**RE: DA 2021/356/1
10-12 View Street CAMDEN**

Alterations and additions to commercial premises including rear addition with storage undercroft, additional at grade car parking, tree removal and associated works

Source: Macarthur Architectural Drafting Services

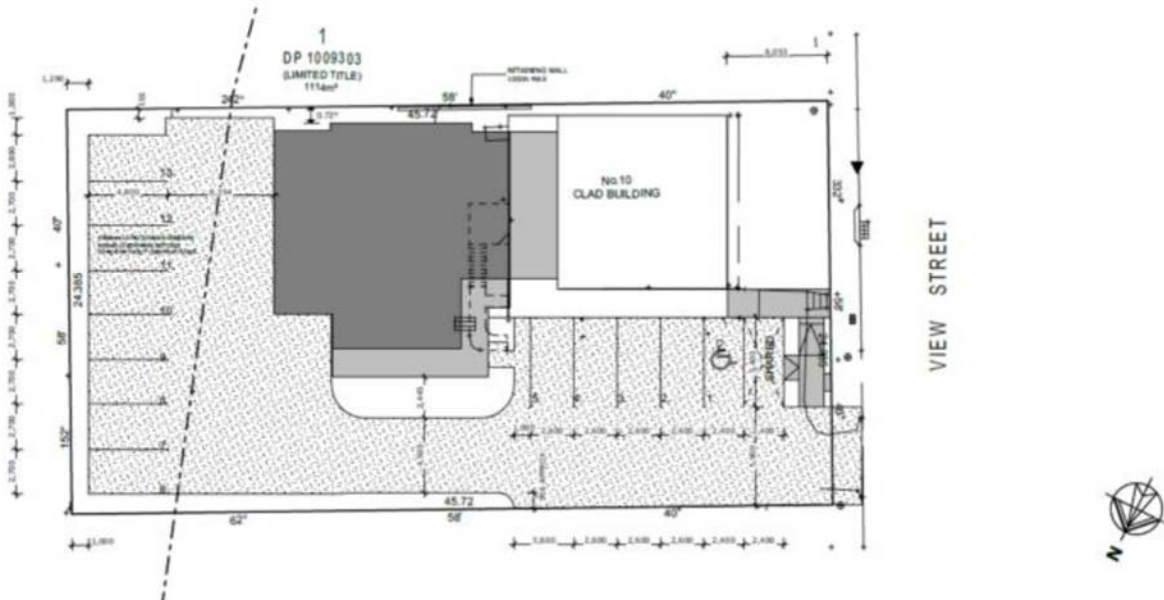
The only justification provided relates to retention of the cottage (HIS, 6.3), not the proposed addition which is very substantial. Its relative scale and form, as demonstrated in the architectural extracts below, cannot be referenced in View Street or other cottage dominated areas of the B4 zone of the HCA.

We surprisingly note that the HIS does not address **DCP 2.16.5 View Street Workers Cottages**. Non-compliances with its Controls are evident in the architectural extracts above and include:

Objection: the proposed addition being of greater scale and footprint than the original cottage cannot be described as subservient

Objection: the proposed addition extends beyond the side of the cottage and would be visible from View Street.

Objection: there is no evident attempt to contribute to the streetscape through interpretation and referencing of any of these features. The new addition and carpark would be visible from View Street. In particular its roof form, bulk and scale are not compatible with the finer-grained and domestic character of the workers cottage precinct.

Objection: Additional car parking is provided at the side of the cottage building, not behind the front building line and would be visible from View Street.
